Product Change Notice

Smart Display PCB Solder Mask Change

Below is the appearance comparison of HDSP-250x for reference:

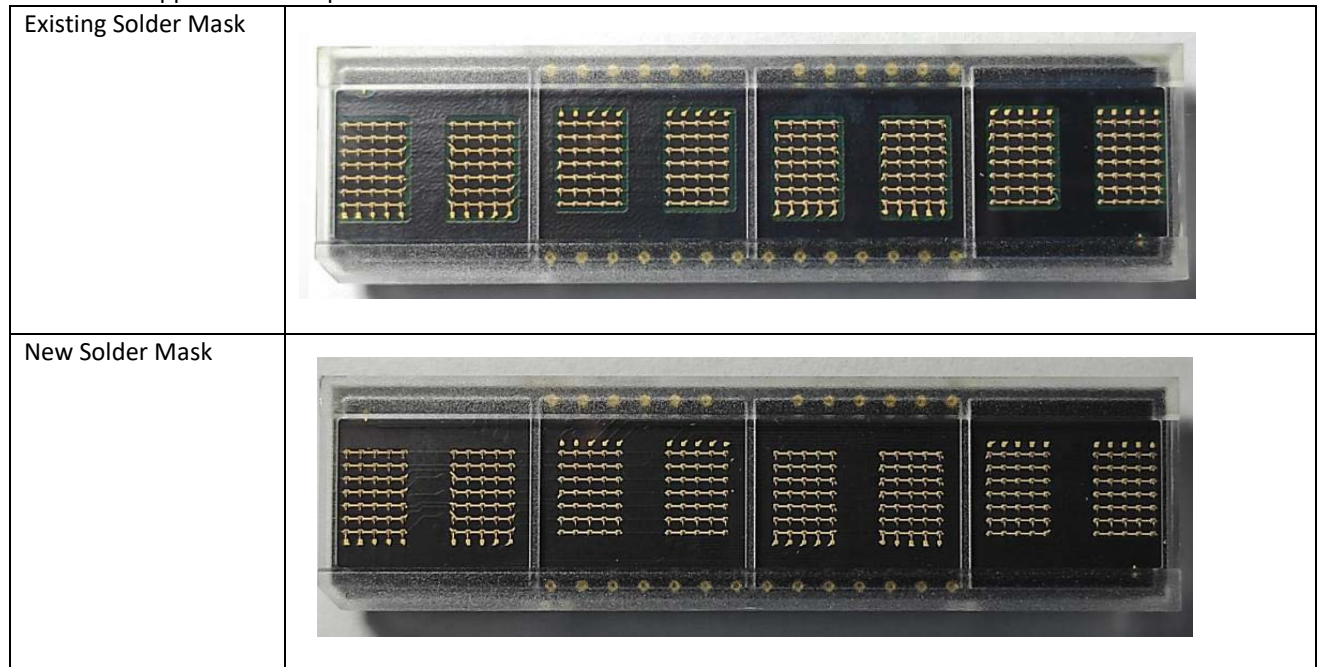
Solder mask optimization and material change. The new solder mask fully covers the PCB, providing a better cosmetic appearance.
